# **Review of PREPA Technical Requirements for Interconnecting Wind and Solar Generation**

**Technical Report**  
NREL/TP-5D00-57089  
November 2013

The Puerto Rico Electric Power Authority (PREPA) has established minimum technical requirements (MTR) for interconnection of wind turbine generation and photovoltaic (PV) power plants (see Appendices A and B). During a stakeholder workshop conducted by the U.S. Department of Energy (DOE), the National Renewable Energy Laboratory (NREL), and the Government of Puerto Rico in May 2012, barriers to renewable energy deployment were discussed. The stakeholders, including PREPA, the Puerto Rico Energy Affairs Administration, and representatives from the Governor's Office, requested DOE and NREL assistance in a technical review of the MTRs for variable renewable energy generation.

**Figure 15. Wind power participation in AGC (NREL model)**

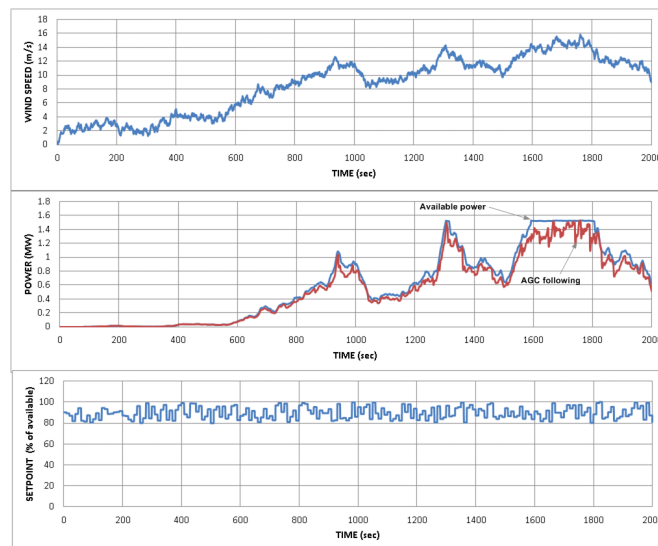
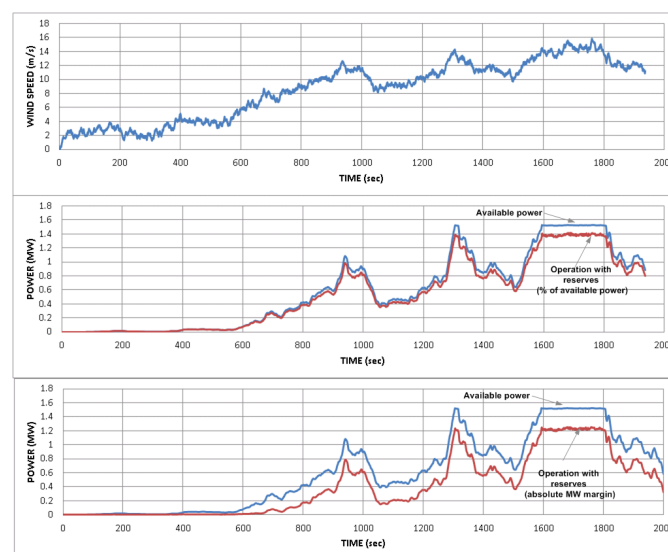
One important question that might affect the MTRs is if PREPA envisions wind and PV participation in automatic generation control (AGC) at some point in the future. If so, then such capability must be requested in the requirements. An example of wind power participation in AGC is shown in Figure 15, where a wind turbine is able to follow AGC signals by having available reserve margins for up regulation.

There are other active power control schemes for wind power rather than inertial/PFR and RR limiting. If required, wind power can operate with spinning reserves as shown in Figure 16. It can provide continuous reserves as a percentage of available power or absolute reserves in megawatts.

Such advanced active power control schemes might be beneficial to PREPA under certain circumstances. During periods of high wind production at light loads, fossil fuel units may need to be forced offline due to the excessive wind power, which leads to another problem of inadequate unit dispatch capability in system operations. The excessive wind power could serve as a dispatchable reserve rather than just curtailing for security concerns. In addition, such capability could release the regulation of diesel and other combustion generation when a high concentration of wind power is installed in an isolated island grid.

**PREPA's Response to Recommendation #14:**

PREPA asked for the minimum known necessary technical requirements that were important for optimizing the power system performance under high levels of renewables penetration, while providing the necessary mitigation to the impact of these resources on the electric system. Recognizing the level of complexity that the implementation of such advanced active power control schemes might have on the projects, PREPA has decided not to require renewables to provide or participate in AGC at this point in time. However, PREPA understands the benefits of these services by renewables, and may require them in the future if necessary.
